Comment on Representation Relating to Draft Plan

**Comment on the Representations to
Draft Wan Chai Outline Zoning Plan No. S/H5/28**

Lee Theatre Realty Limited
Representation on the Draft Wan Chai Outline Zoning Plan No. S/H5/28
Relating to Lee Theatre Plaza, 99 Percival Street, Causeway Bay

**Representation in relation to the
Amendments to the Draft Wan Chai Outline
Zoning Plan Number S/H5/28**

Figure 2: Photomontage showing the view from the Stubbs Road Lookout Point.

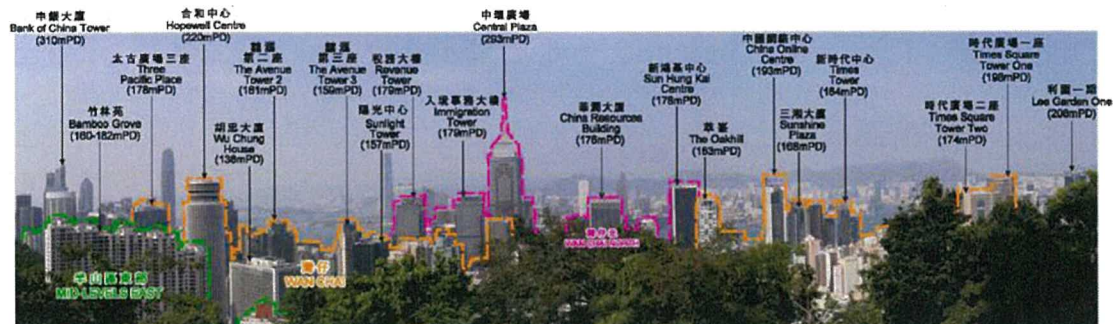
At 165mPD the building would not be able to be seen from the Stubbs Road Lookout Point. There is no real justification given for the 135mPD BHR. If we look at the photomontages prepared by Planning Department which were included in the TPB Paper as Plans 9A-9E it becomes apparent that Lee Theatre Plaza at 165mPD is not visible in any of the photomontages. Plan 9E, is the specifically mentioned photomontage in relation to this site of the view to the harbor from Stubbs Road Lookout Point (**Figure 2**). It seems difficult when looking at this photomontage to describe the proposed 165mPD BHR as excessively tall or affecting the view to the point where the "societal benefits" outweigh the burden placed on the landowner, when the building would not be visible from the mentioned viewpoint as it is too short to be seen amongst the surrounding taller buildings and trees.

Figure 3 : 135mPD OZP and SBDG Compliant Scheme.

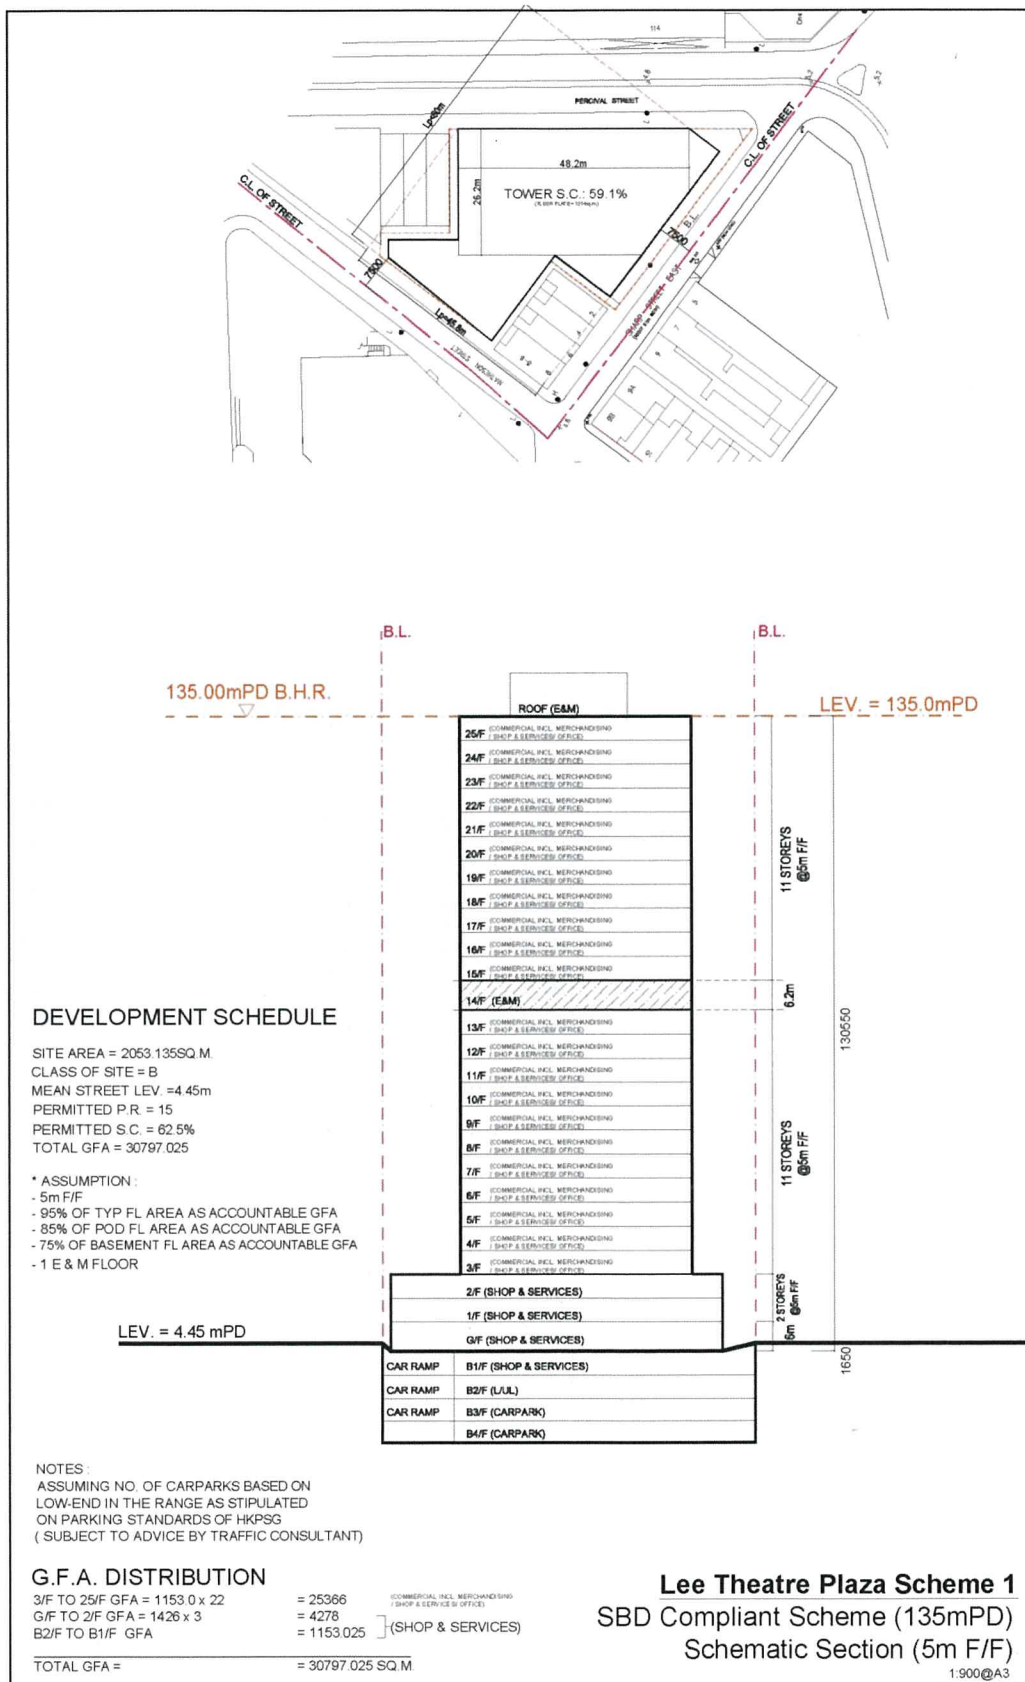
- 9.2 This scheme is designed to comply with the proposed 135mPD BHR (see **Figure 3**). To comply with the SBDG it is necessary to have a small podium setback at the ground floor level on Sharp Street East, in addition to a very small setback on part of the building frontage onto Matheson Street. The length of the tower is limited due to the smaller size and unusual shape of the site the building length makes it difficult to have an efficient floorplate. The Ginza Style Commercial building (see **Figure 7**) needs a 5m floor-to-floor height to cope with modern requirements, which has been generally accepted by Buildings Department, and therefore this is the assumed floor-to-floor height.

- 9.3 The relatively low BHR of 135mPD necessitates the provision of one basement floor below ground level to accommodate the balance of the GFA. This is contrary to the assumption made by Planning Department not to have any such floor for these uses in the basement. With the parking and loading/unloading requirements, this would effectively mean provision of 4 basement levels, which is an unnecessarily large excavation, environmentally unsustainable, and expensive.
- 9.4 There are no green features or amenities able to be accommodated within the building design such as sky gardens in the 135mPD Scheme.

Figure 4 : The 165 mPD SBD Complaint Scheme

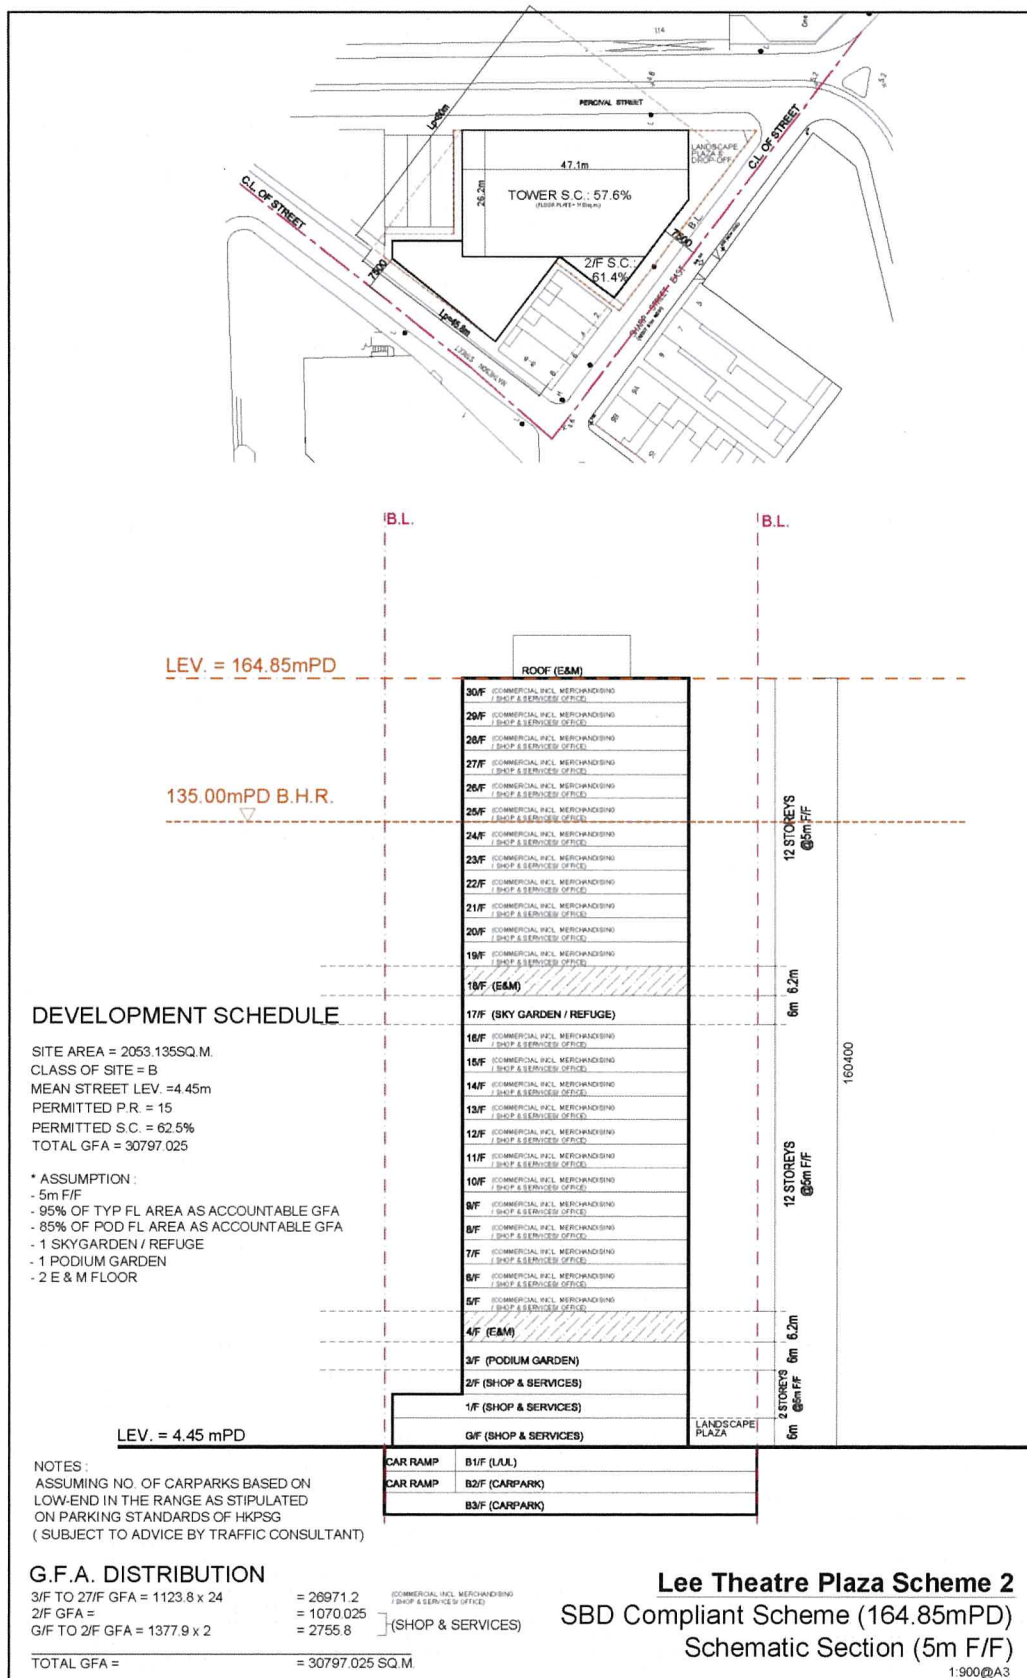
- 9.1 The Representor's AP has been requested to prepare two schemes to illustrate the different options for the site. The first scheme (**Figure 3**) is the 135mPD scheme showing the impact of the normal application of the SBDG on the development of the Lee Theatre Plaza site under the 135mPD BHR. The second is an indicative scheme of some of the features that could be incorporated if the BHR was raised to 165mPD (**Figure 4**).

- 9.7 The ability to incorporate sky gardens and podium gardens as well as reduce the bulk of the podium would aid air ventilation in the area. The visual impacts of the 165mPD tower are non-existent from the viewpoints shown in the TPB Paper, and negligible in terms of the naked eye from street level. The building will still be visually a high-rise and visually still shorter than the surrounding buildings. From a visual and also user experience the 165mPD building provides the opportunity to incorporate more design and green features and enhance the area with minimal visual impact.

Figure 3: Photomontage showing the view from the Stubbs Road Lookout Point.

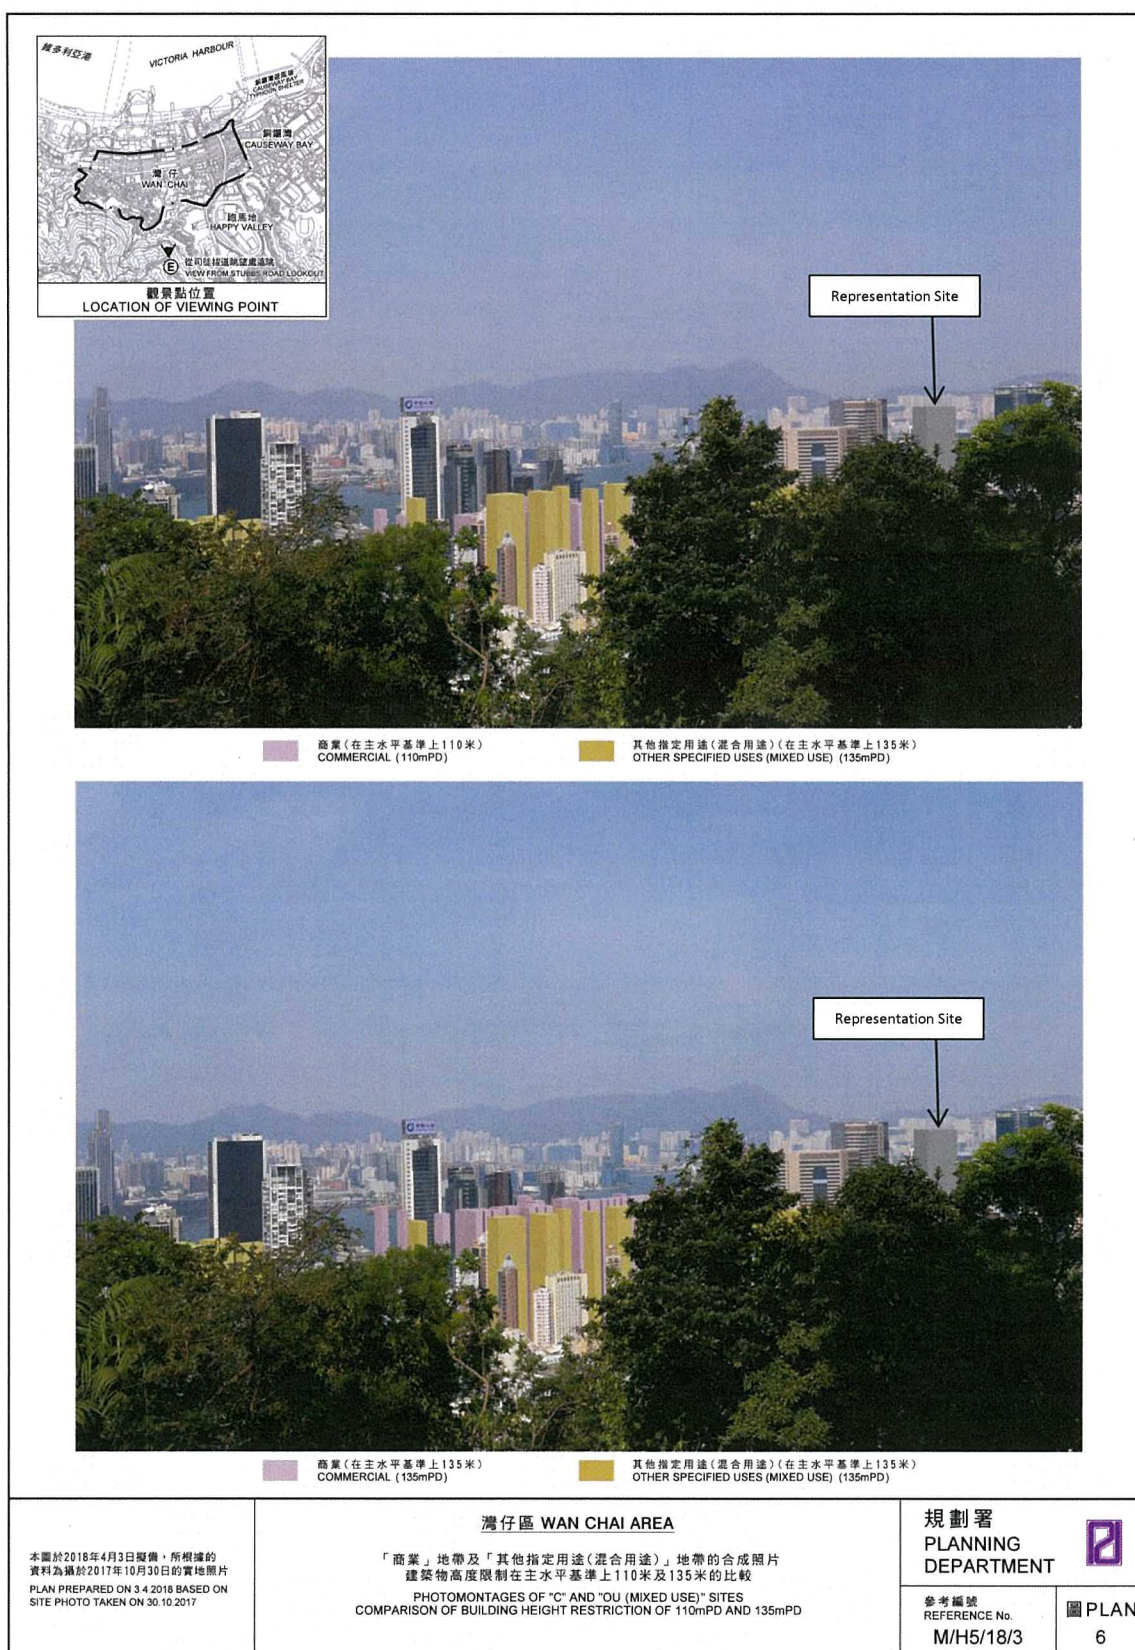
However, there is no real justification given for the 135mPD BHR. If we look at the photomontages prepared by Planning Department which were included in the TPB Paper as Plans 9A-9E it becomes apparent that the Leighton Centre at 200mPD is either not visible or so insignificant it is visually very difficult to distinguish where it is. Plan 9E, is the specifically mentioned photomontage in relation to this site of the view to the harbor from Stubbs Road Lookout Point (**Figures 2 and 3**). It seems difficult when looking at this photomontage to describe the approved GBPs as excessively tall or affecting the view to the point where the “societal benefits” outweigh the burden placed on the landowner. In fact, the building appears to be visually in context with those surround it and rather visually insignificant from this viewpoint.

Figure 4 : 135mPD OZP and SBDG Compliant Scheme.

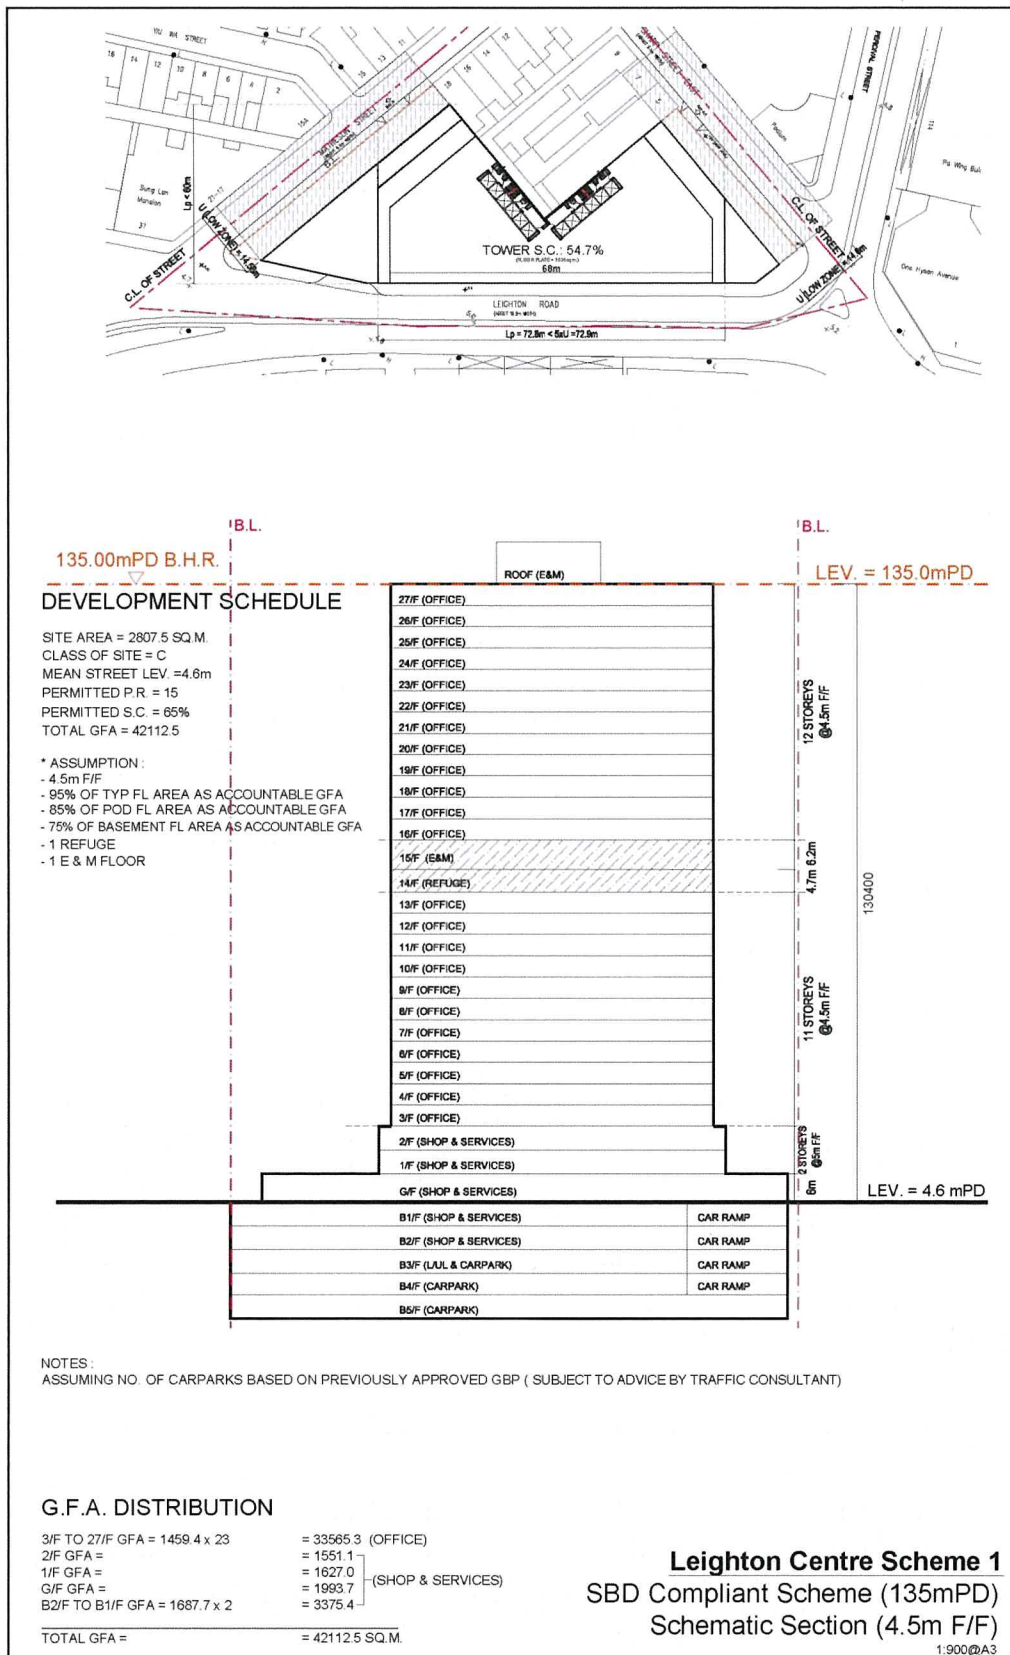
- 10.2 This scheme is designed to comply with the proposed 135mPD BHR (see **Figure 4**). To comply with the SBDG it is necessary to have small podium setback at the ground floor level on both Matheson Street and Sharp Street East. The length of the tower is also limited under SBDG. Due to the unusual shape of the site the

building length makes it difficult to have an efficient floorplate when also complying with the SBDG. The 4.5m floor-to-floor height is assumed as it is the minimum acceptable floor-to-floor height for a Grade A Office Building. Buildings Department now routinely approves a 5m floor-to-floor height for commercial buildings and so a 4.5m assumption is reasonable.

- 10.3 The relatively low BHR of 135mPD necessitates the provision of two basement floors below ground level to accommodate the balance of the GFA. This is contrary to the assumption made by PlanD not to have any such floor for these uses in the basement. With the parking and loading/unloading requirements, this would effectively mean provision of 5 basement levels, which is a very large and prohibitively expensive excavation. As a business case, this scheme is inferior to the Approved GBP Scheme and not a realistic viable commercial option for the Representor.

Figure 5 : The 200mPD GBP Approved Scheme

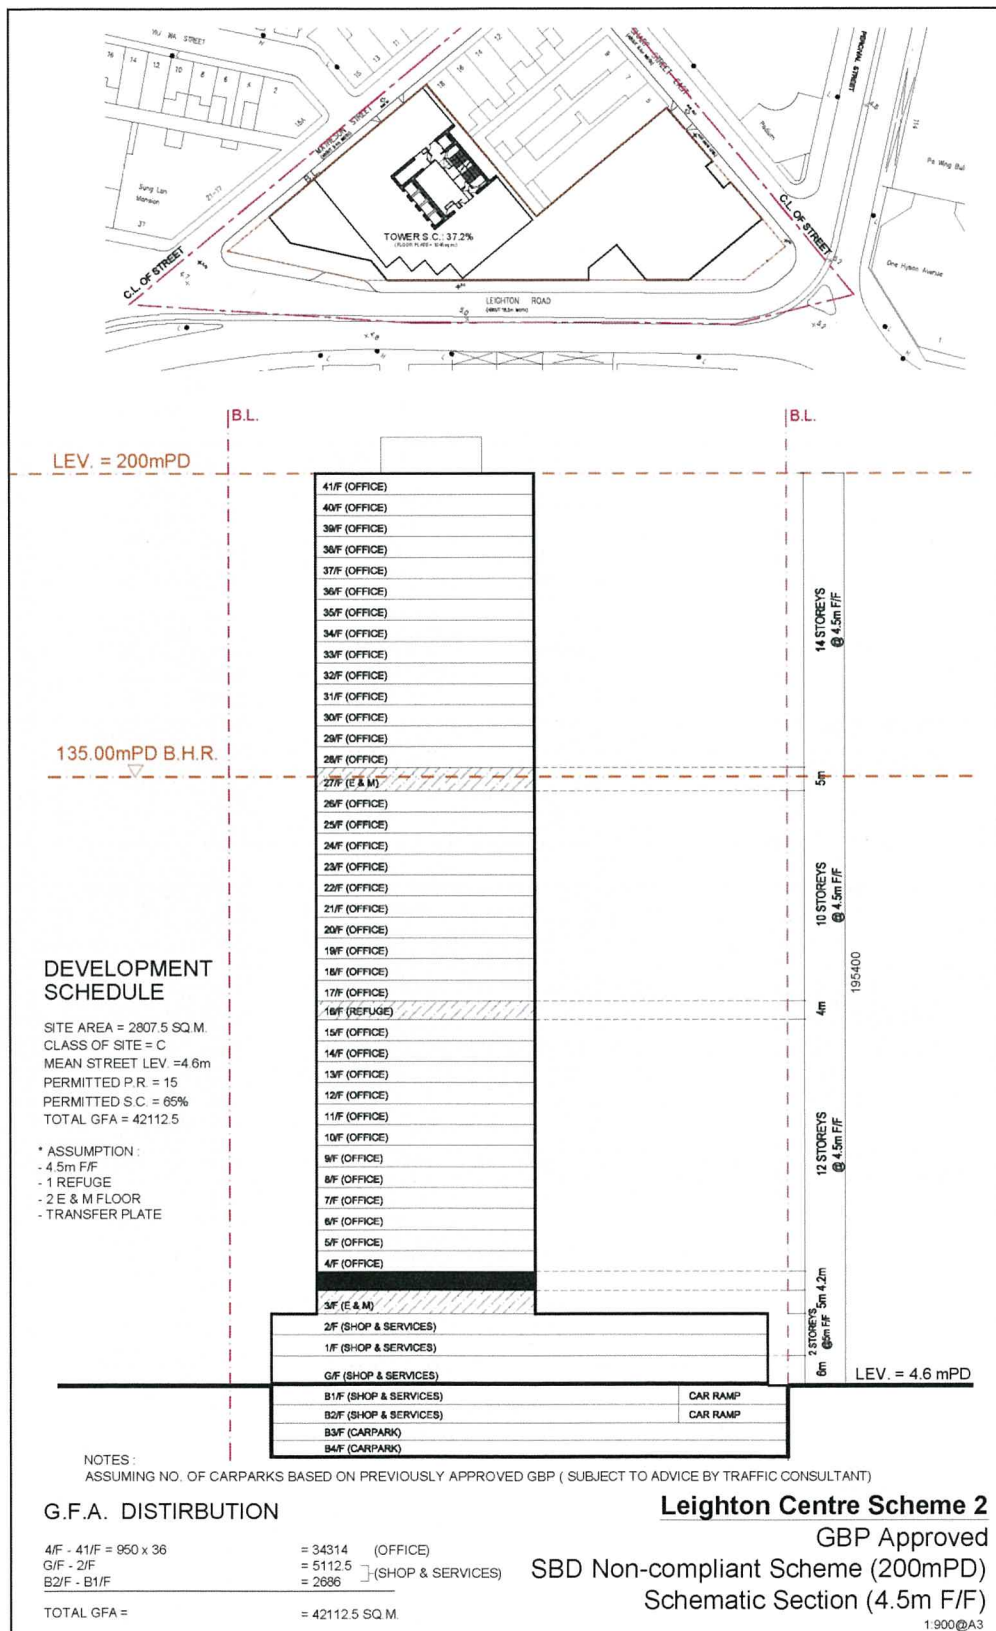
- 10.4 The approved GBP Scheme is 200mPD (see **Figure 5**), and has a more efficient tower footprint. The 3 floors of podium are large floorplates, with some voluntary setbacks located in a few places. There are no green features and are 2 storeys of retail in the basement levels. The floor-to-floor height is 4.5 for the tower. The scheme was never intended to be built without substantial modifications as the detailed design process progressed, but it is a scheme that can be built and operated as a very standard commercial development. It would not be a typical Hysan development as it has no green features, no place-making contribution and it also has no green features. It has very little public benefit. It is however a scheme that from a business case perspective is possible to justify, while not congruent with the best-practice redevelopment ethos of Hysan Place.
